**SUMMARY OF SUBMISSIONS**  
**Karbro Drive, Cardup 26 (L87) 143801 – Section 31 Reconsideration – SJ4210**

5

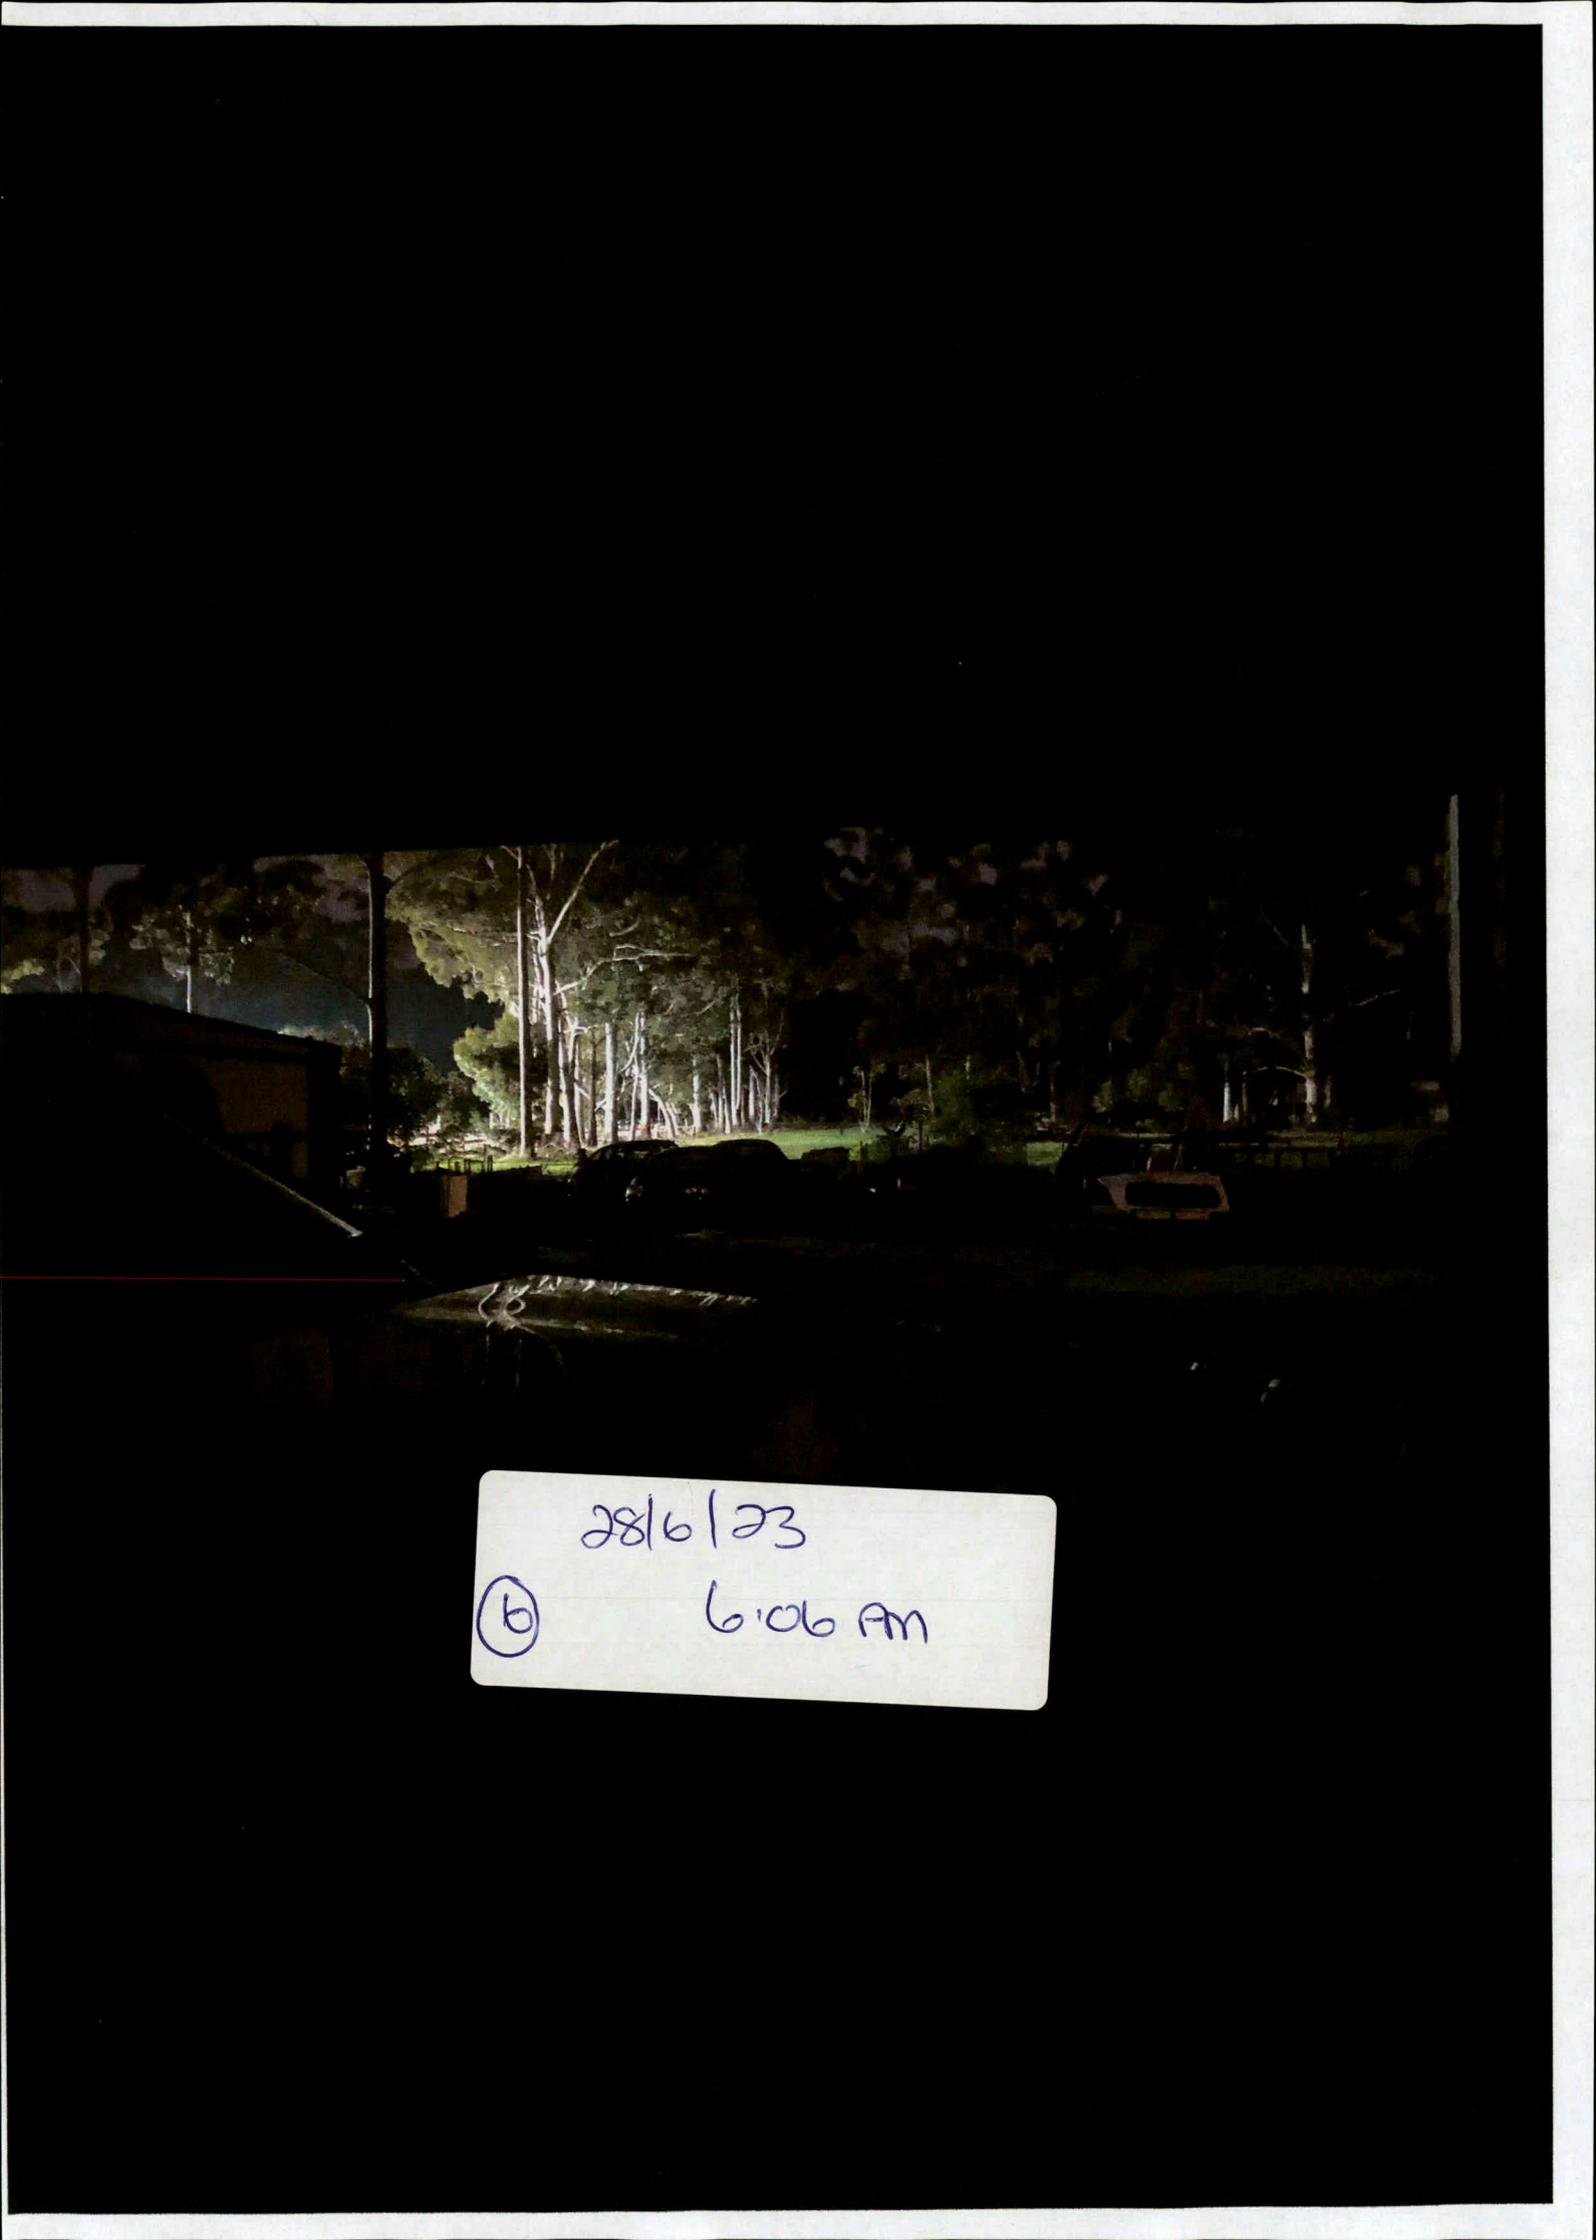
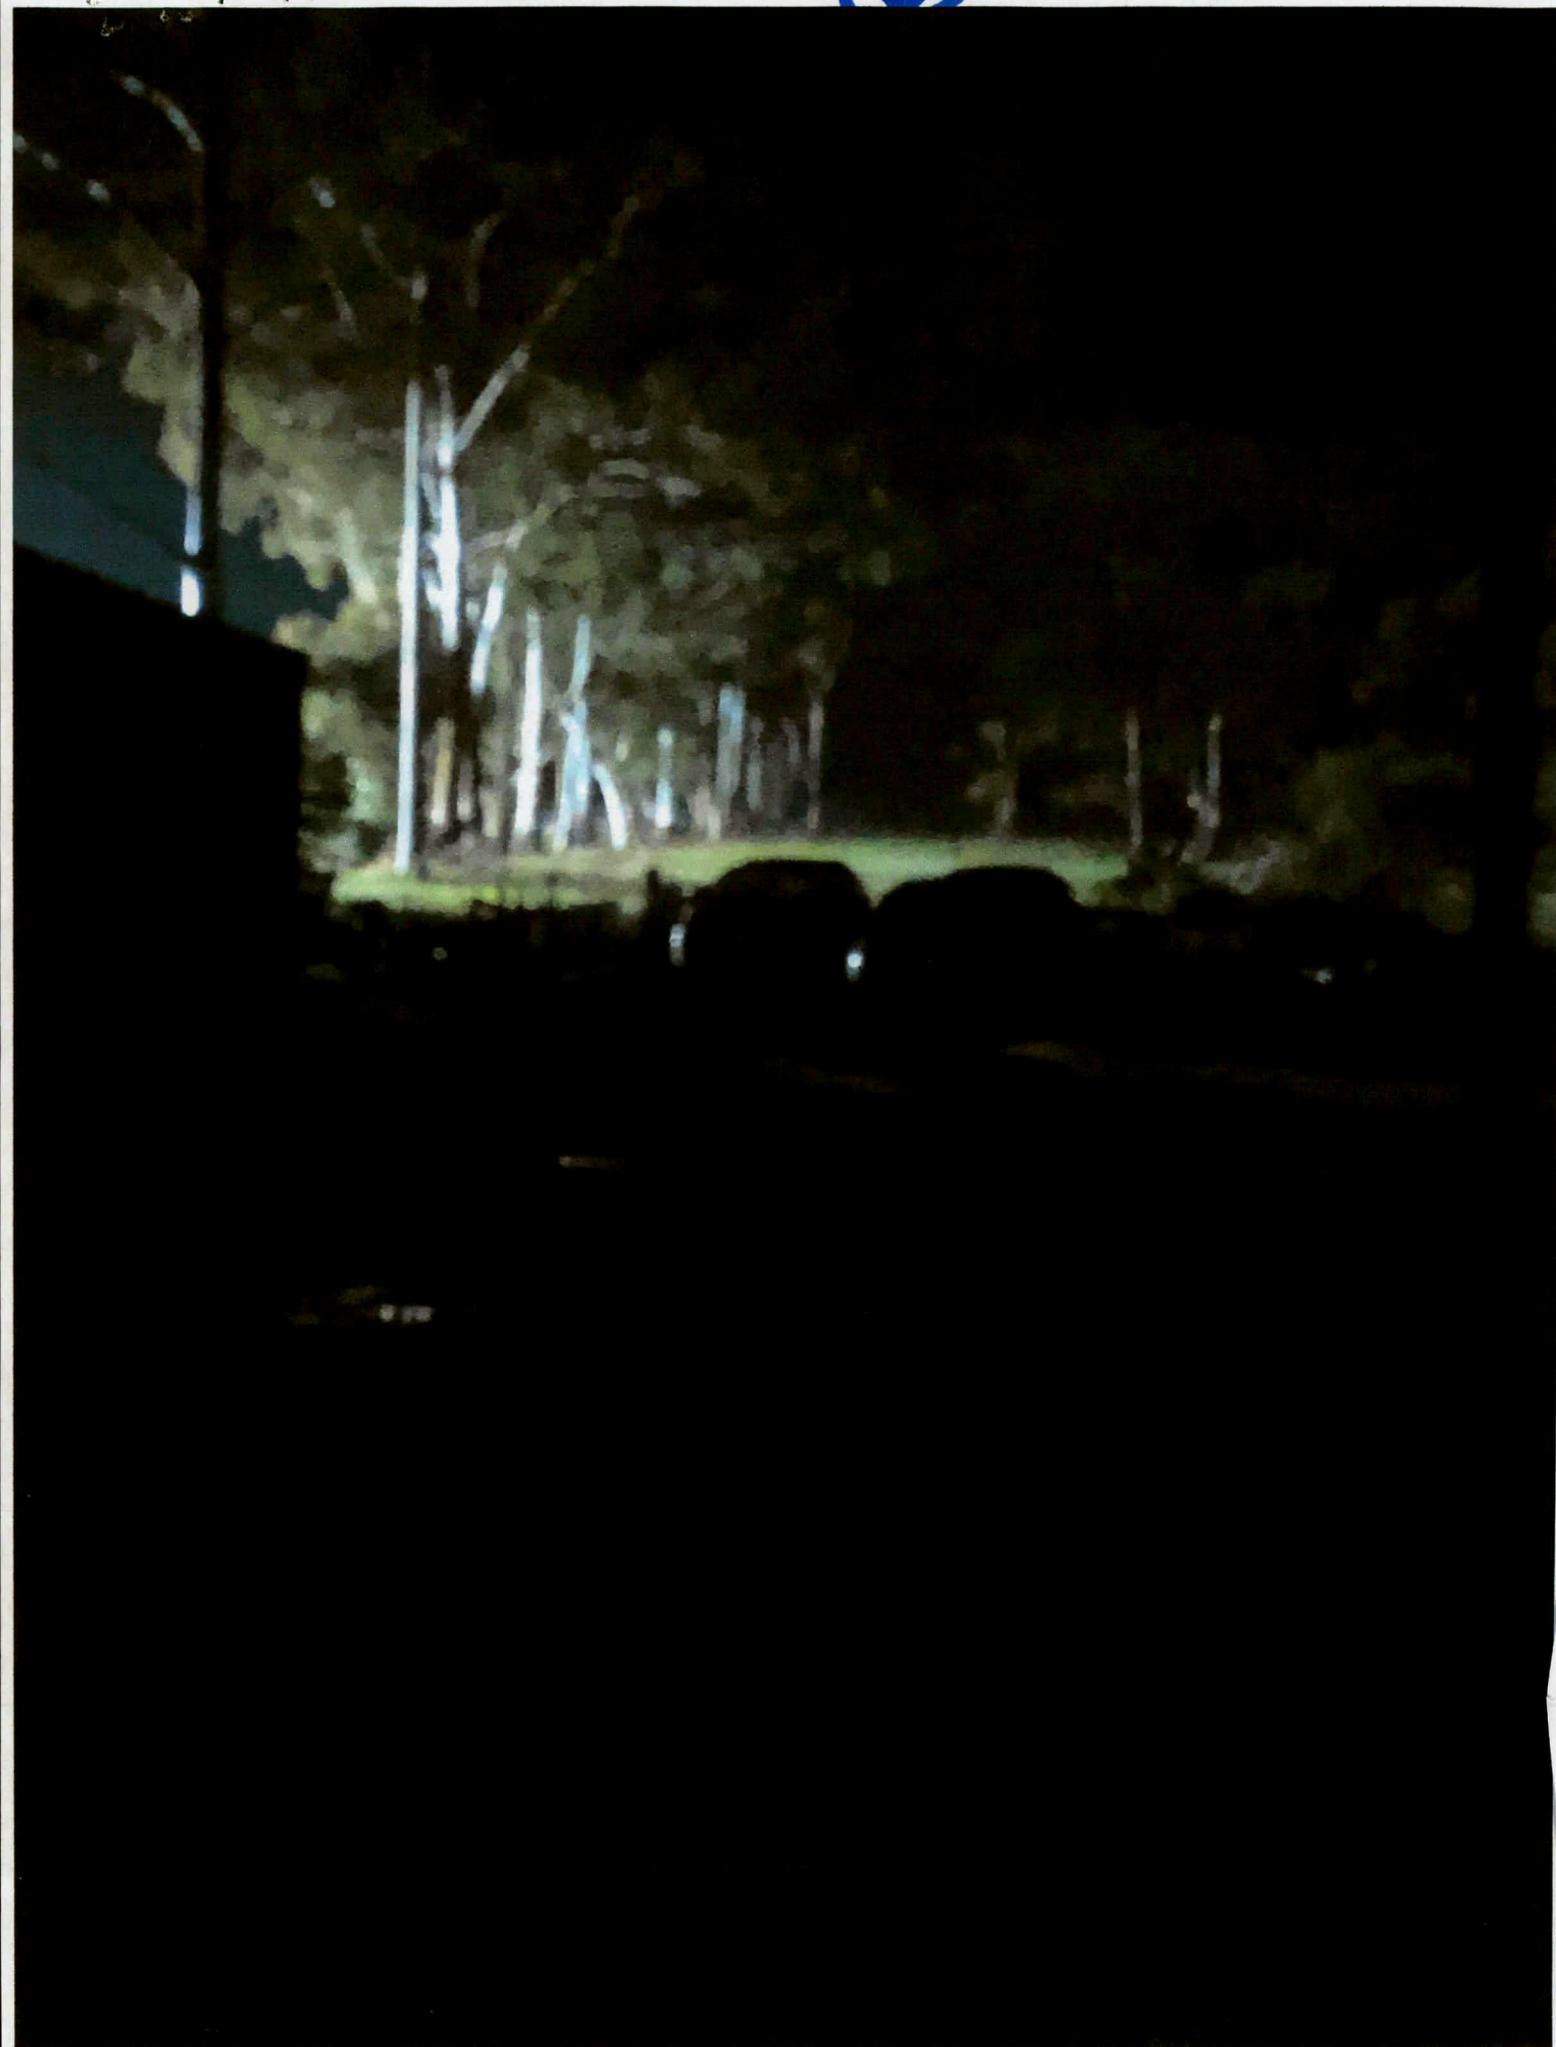
- 1) 18/5/22 — 9.02 PM
- 2) 28/7/22 — 6.32 AM
- 3) 16/9/22 — 6.34 AM From our front paddock
- 4) 3/1/23 — 8.10 AM
- 5) 8/6/23 — 6.59 AM
- 6) 28/6/23 — 6.06 PM
- 7) 6/7/23 — 5.49 AM on prior To 6 AM
- 8) 6/7/23 — 6.48 PM.

good comparison of no change  
in light spill from  
18/5/22 — 28/6/23

Figure 5: Drone footage showing arena light spill at night

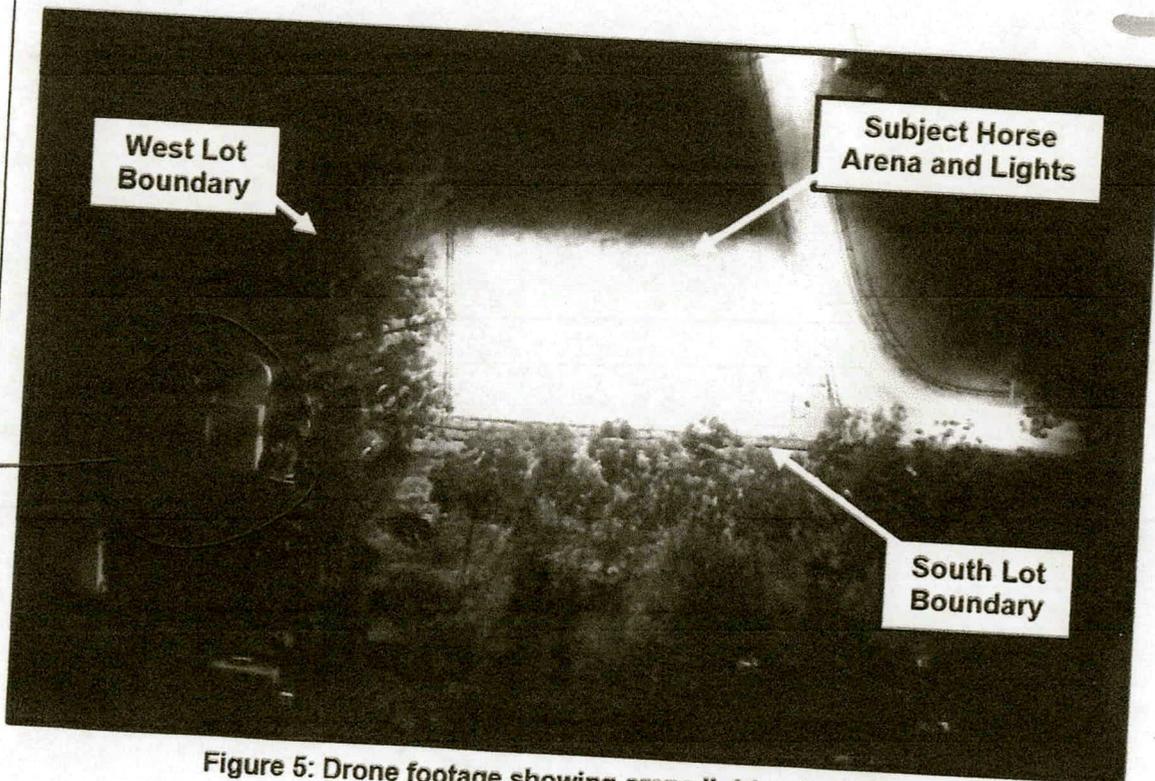
In terms light spill, the application confirms that the lights have been angled to a 14-degree angle which results in light spill occurring to a depth of 3m to the property to the south. Officers note however, that based on the aerial drone image below the spill appears to be greater. To address this, Officers consider light shields can be installed which angles light in a controlled manner inside the property, avoiding light spilling outside of the boundary. A condition requiring further angling of the lights, or light shields being installed, is also recommended in order to reduce spill to no more than 3m to the property to the south.

Our tanks

BS.

Attachment 4

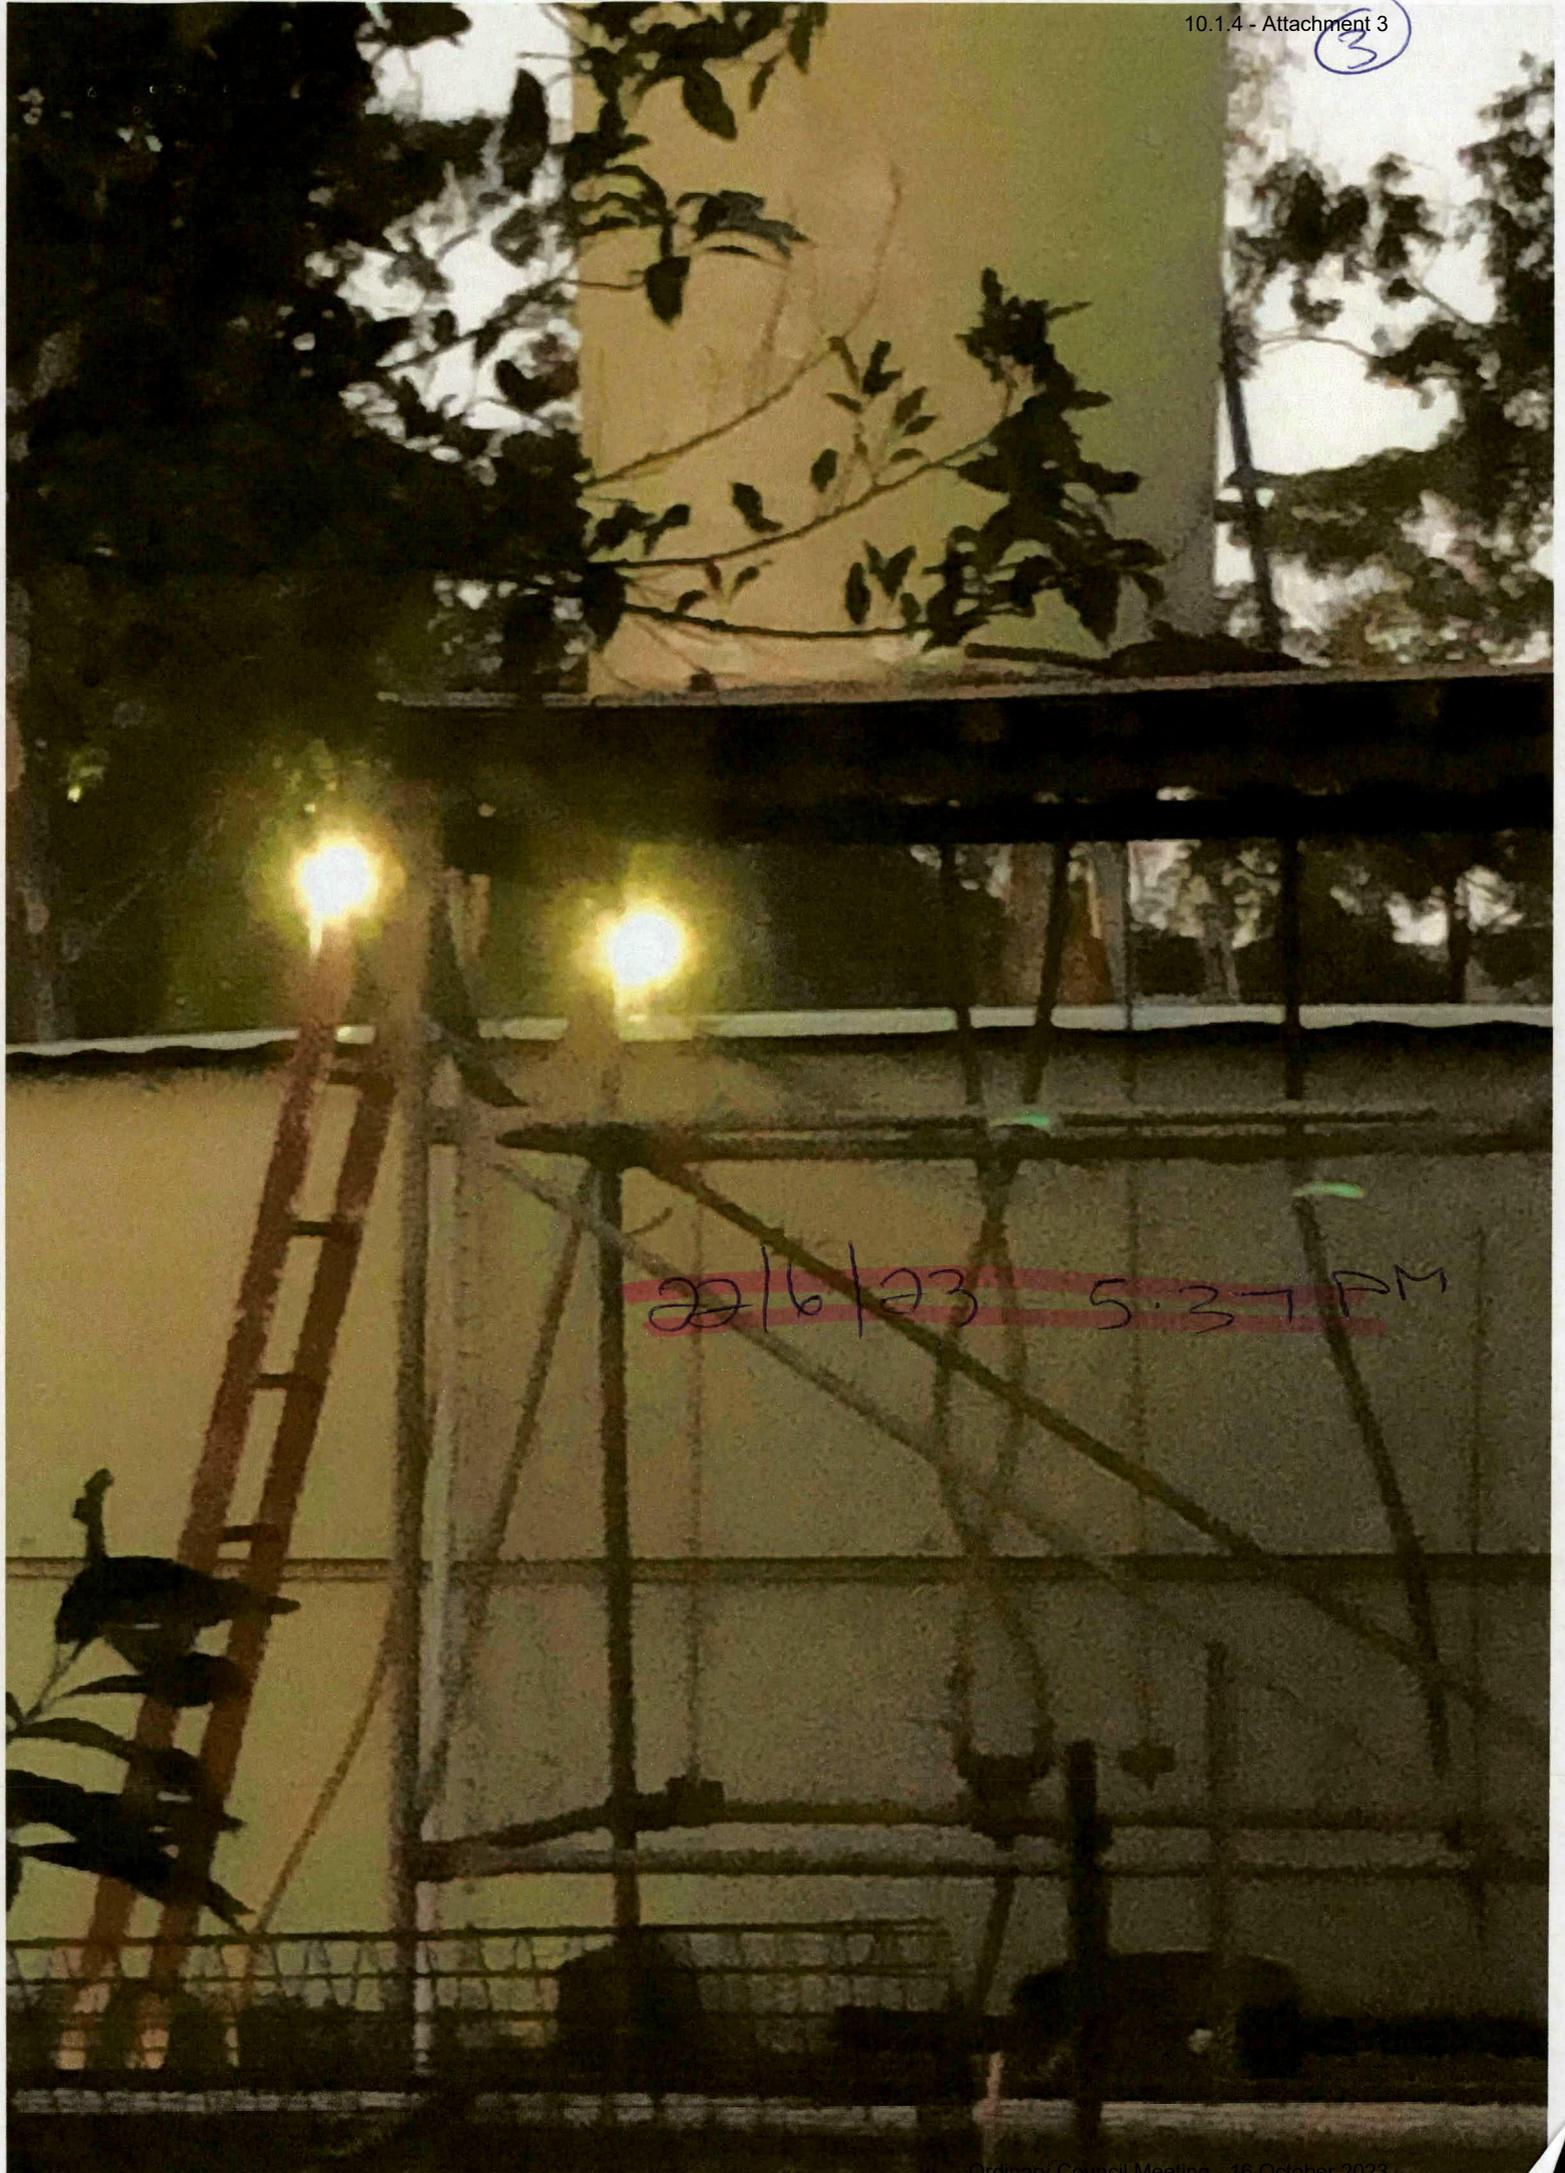
Arena Lights on prior to 6 PM

- 1) 6/7/23 5.49 PM
- 2) 28/6/23 5.46 PM
- 3) 22/6/23 5.37 PM

Lights on our property

- ④ 8/6/23 6.50 ~~PM~~ PM
- ⑤ 11/6/23 6.06 PM
